Access Compliance Report

Public Rights-of-Way

Intersection ID: 42726	Main Street: CAMPION_CT	Cross Street: PICKEREL_LN	Location: W
ADA ID: 78DADBA63DC5	Ramp Type: PerpDiag	Initial Pass/Fail: Fail	Overall Compliance: No
		Severity Score: 10

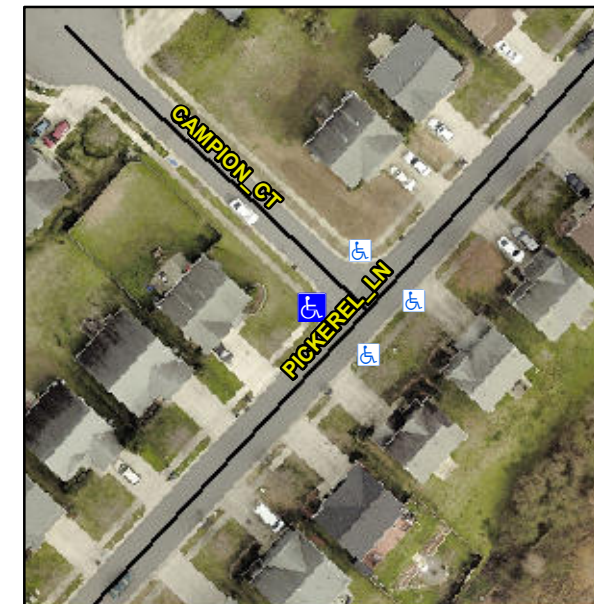
Not Found, R304.5.1, R304.5.3

Compliance	Description	Data	Compliance	Description	Data
N/A	Ramp Length (in)	48.0	Yes	Ramp Slope (%)	5.8
No	Ramp Width (in)	37.0	No	Ramp XSlope (%)	4.6
N/A	Flare Type LT	N/A	N/A	Flare Type RT	N/A
N/A	Flare Slope LT (%)	N/A	N/A	Flare Slope RT (%)	N/A
N/A	Flare Traversable LT?	N/A	N/A	Flare Traversable RT?	N/A
N/A	Landing Length (in)	N/A	N/A	DWS Provided?	N/A
N/A	Landing Width (in)	N/A	N/A	DWS Contrast?	N/A
N/A	Landing Slope (%)	N/A	N/A	DWS Length (in)	N/A
N/A	Landing X Slope (%)	N/A	N/A	DWS Full Width?	N/A
N/A	Landing Curb? (Y/N)	N/A	N/A	DWS Offset (in)	N/A
N/A	Shared Landing?	N/A			
N/A	Gutter Ponding?	N/A	N/A	Gutter Slope (%)	N/A
N/A	Gutter Lip Ht (in)	N/A	N/A	Gutter X Slope (%)	N/A
N/A	Painted X Walk1?	No	N/A	Painted X Walk2?	No
	X Walk 1 Direction	To SE		X Walk 2 Direction	To NE
N/A	X Walk 1 Width (in)	N/A	N/A	X Walk 2 Width (in)	N/A
	X Walk 1 Slope (%)	6.8		X Walk 2 Slope (%)	5.8
	X Walk 1 X Slope (%)	0.6		X Walk 2 X Slope (%)	6.2

Remove & Replace Curb Ramp With Two New Directional Ramps or Equivalent.
